# PORTEOS LIFT STATION AT PORTEOS CONTEXTUAL SITE PLAN WITH WAIVER

## PORTEOS LIFT STATION CONTEXTUAL SITE PLAN COVER SHEET

JOB NUMBER: 35-001-01 OCTOBER 10, 2019

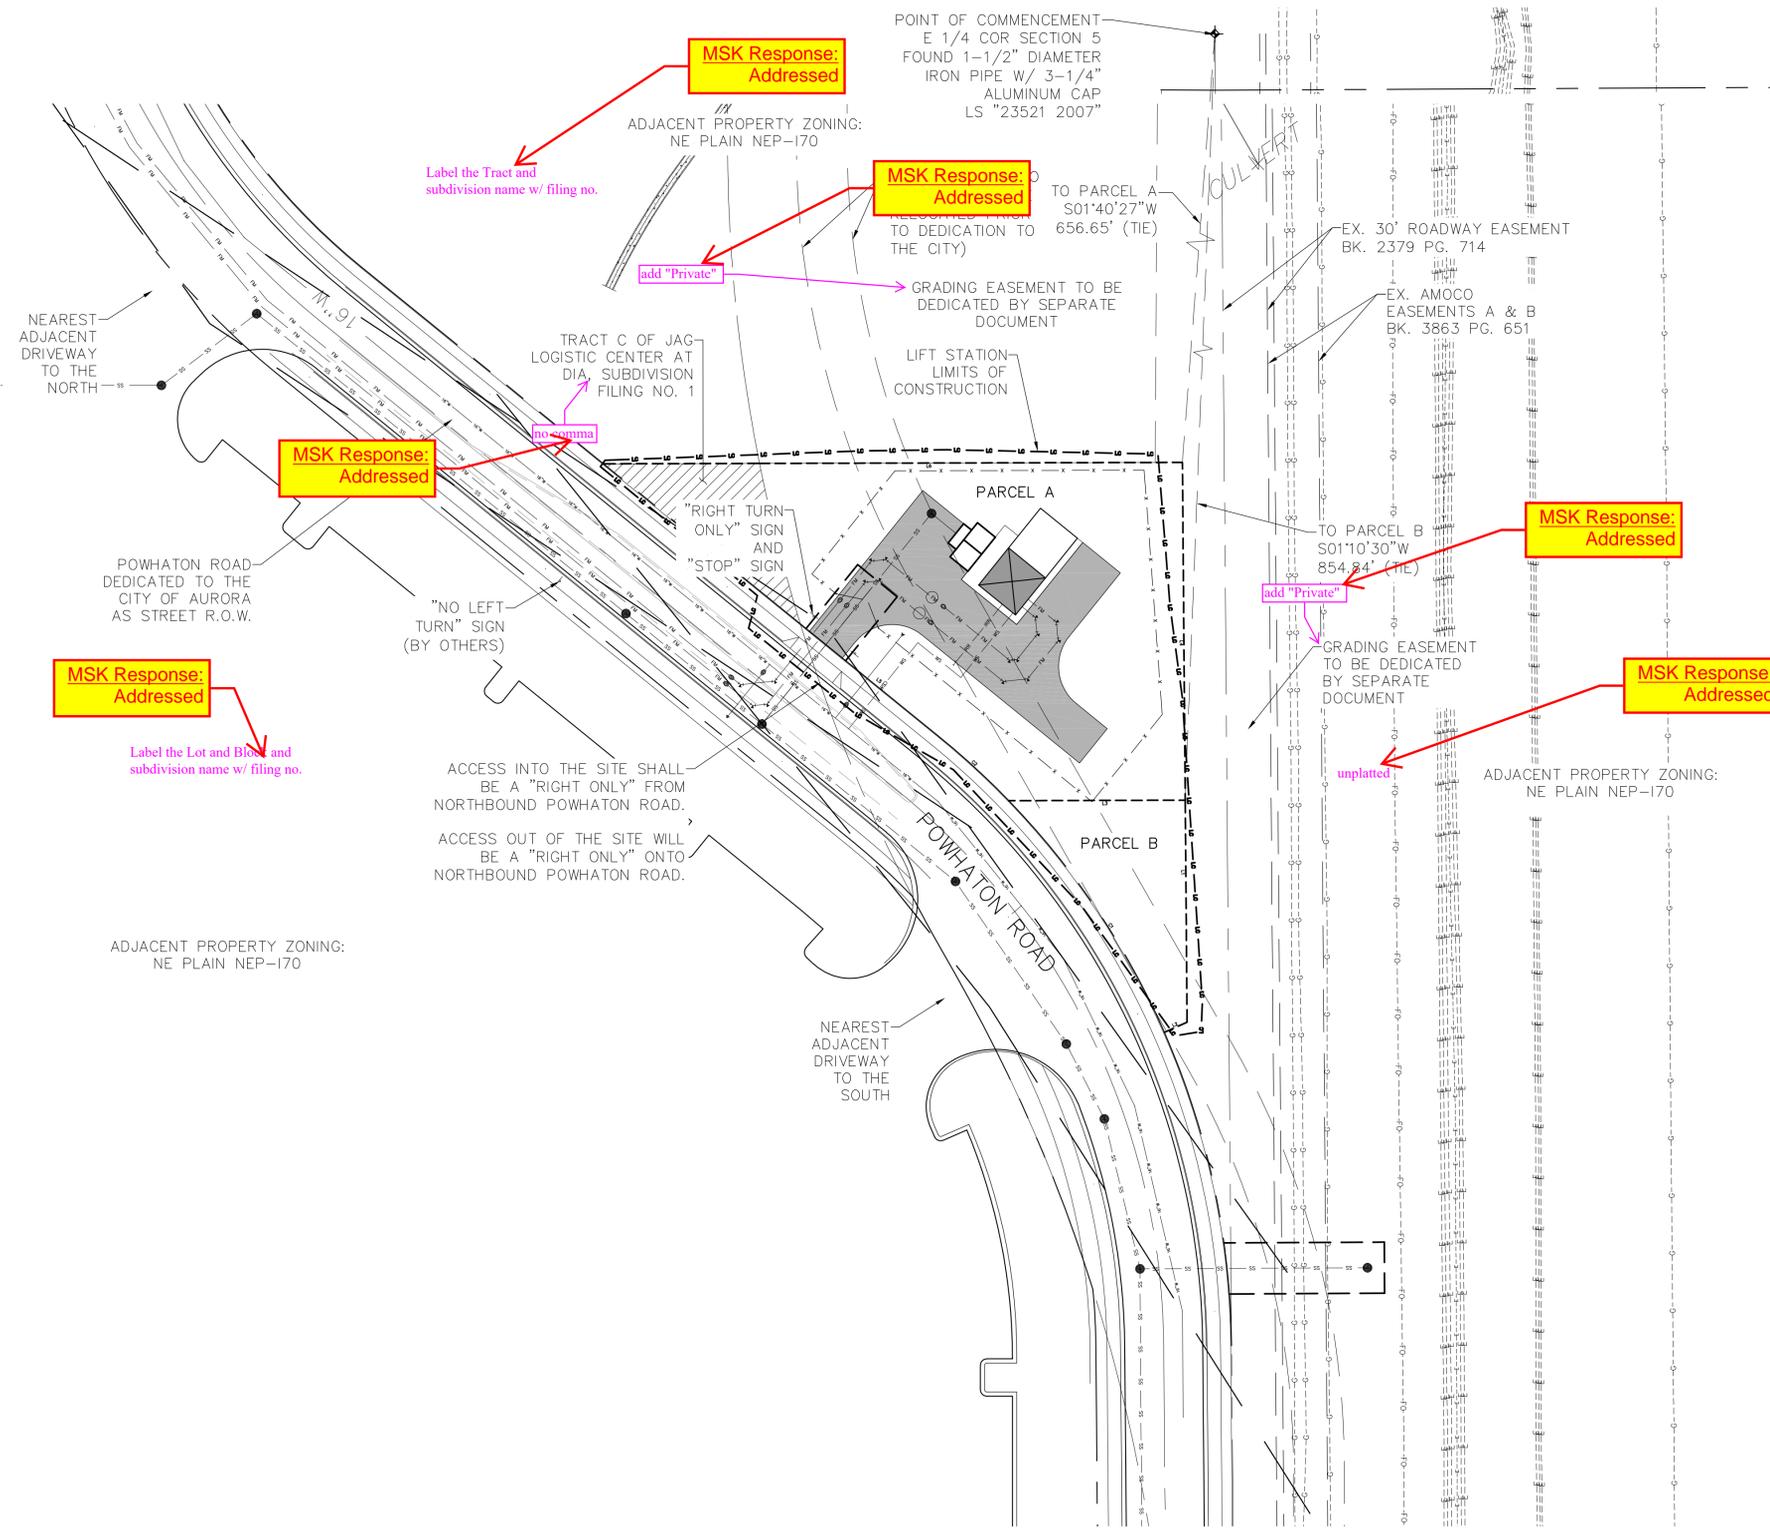
Add the following note: In locations where utility easements overlap drainage easements, only subsurface utilities shall be permitted within the portion of the utility easement that overlaps the drainage easement. Installation of above ground utilities within a drainage easement requires prior written approval by City Engineer

The site plan will not be approved by public works until the preliminary drainage letter/report is approved

Please remove the word Contextual from the Site Plan.

Please remove AutoCad SHX text items in the comment section. Please flatten to reduce select-ability of the items.

MSK Response: Corrected

MSK Response: Noted.

MSK Response: Corrected

MSK Response: Deleted

## PORTEOS LIFT STATION CONTEXTUAL SITE PLAN UTILITY PLAN

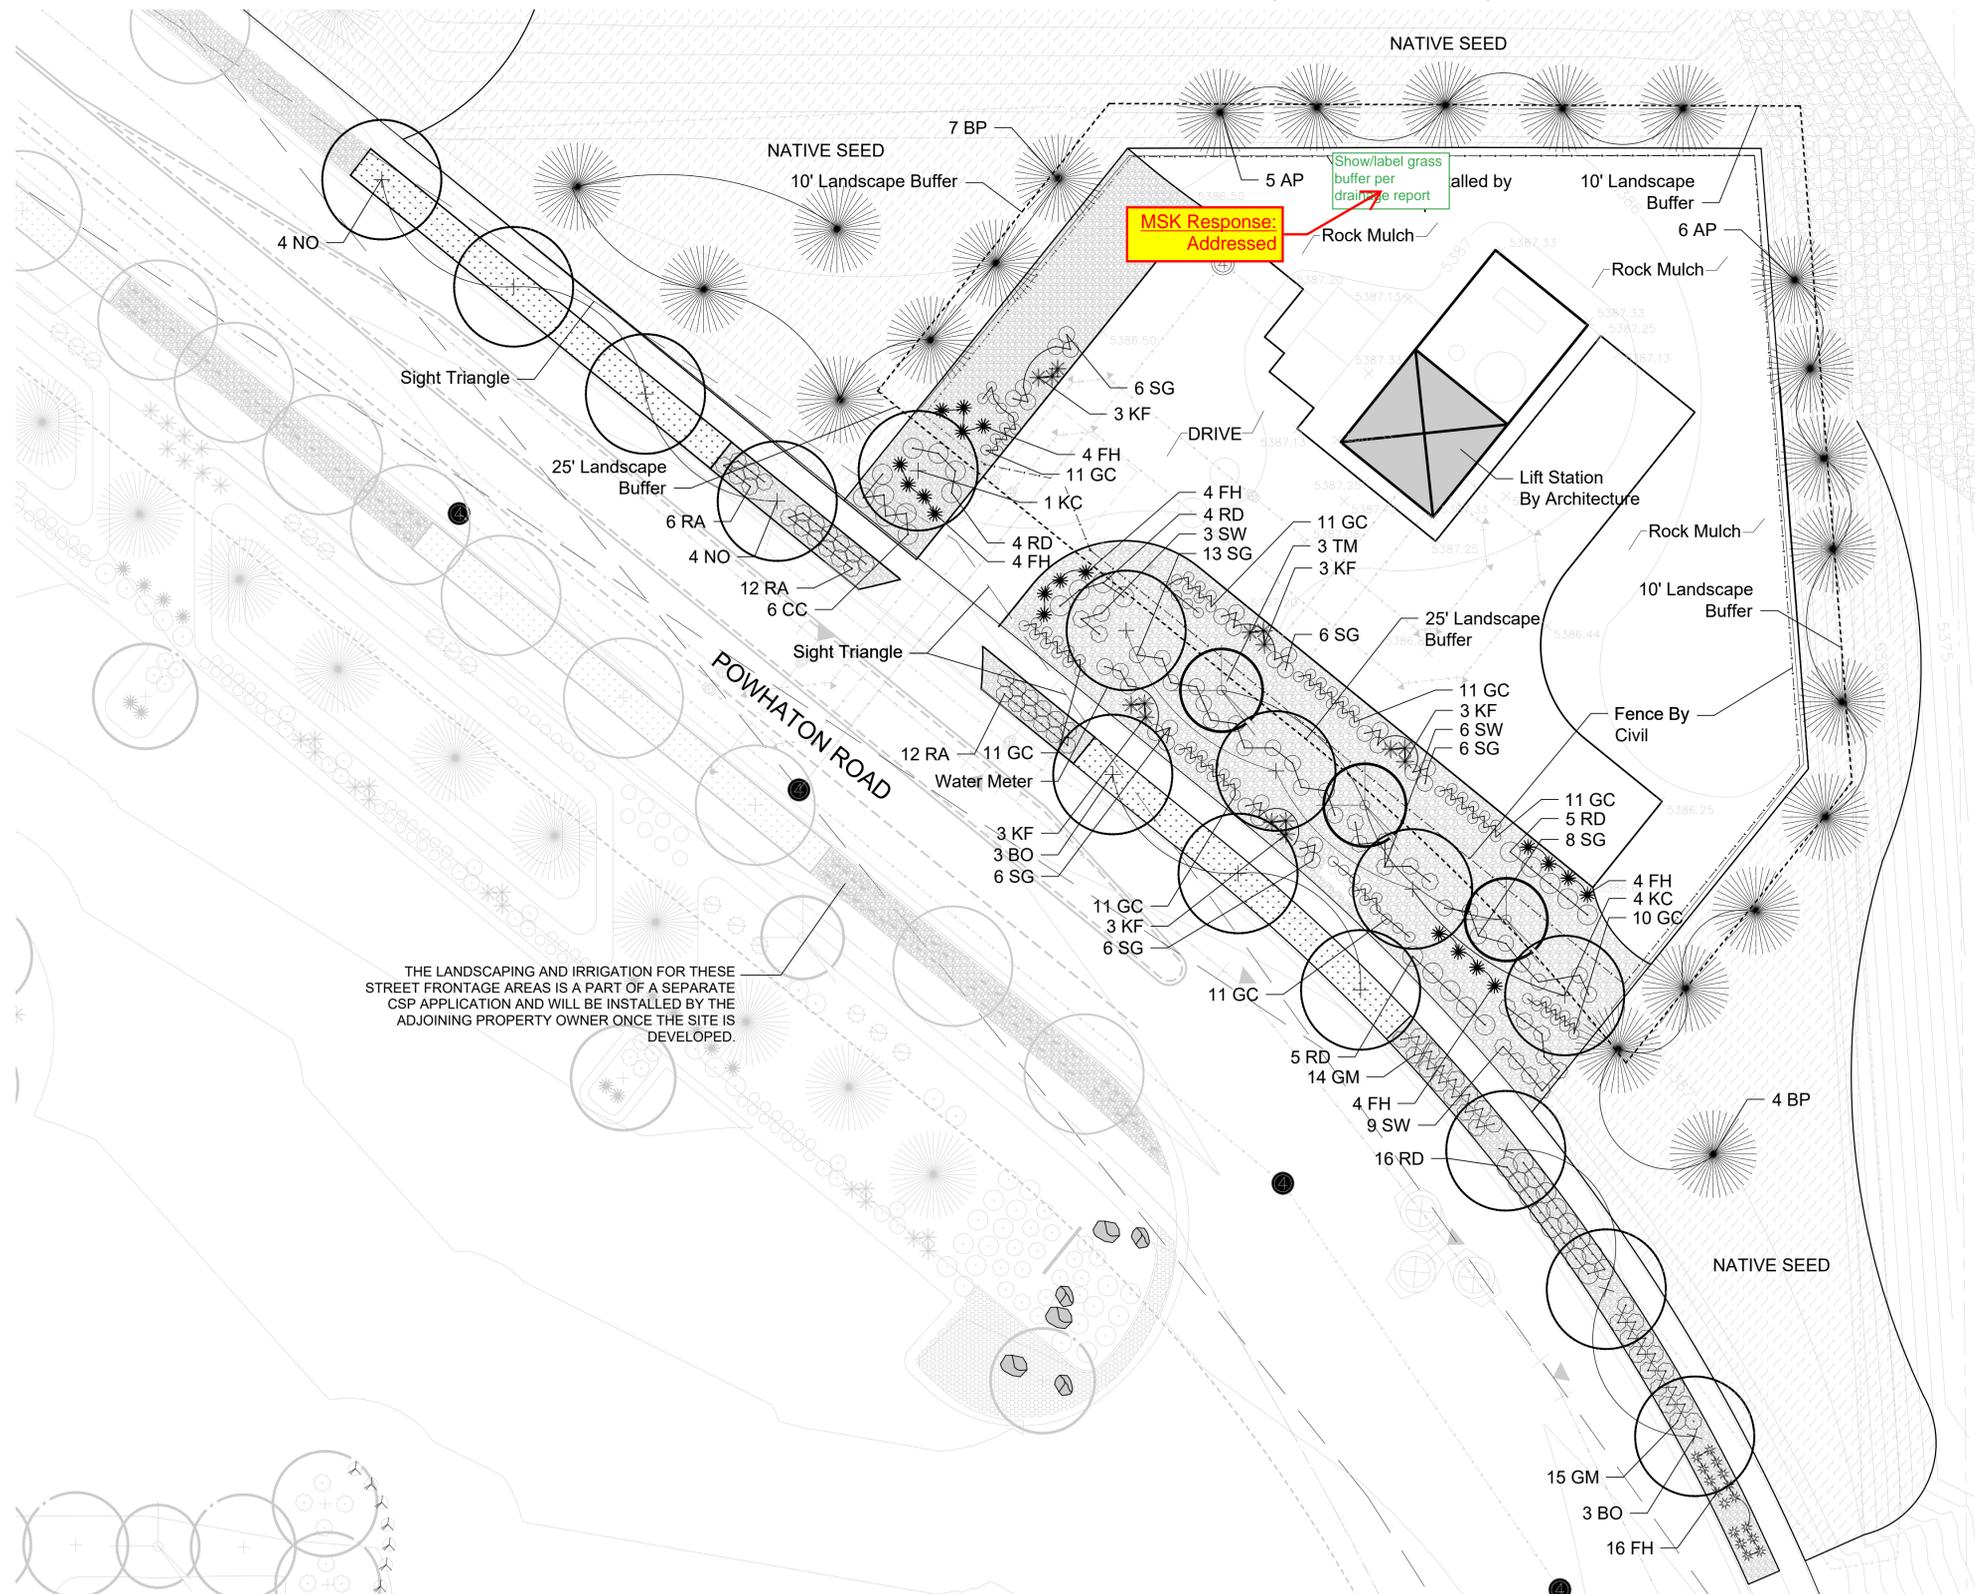
Show/label grass  
buffer per  
drainage report

MSK Response:  
Addressed

MSK Response:  
Addressed
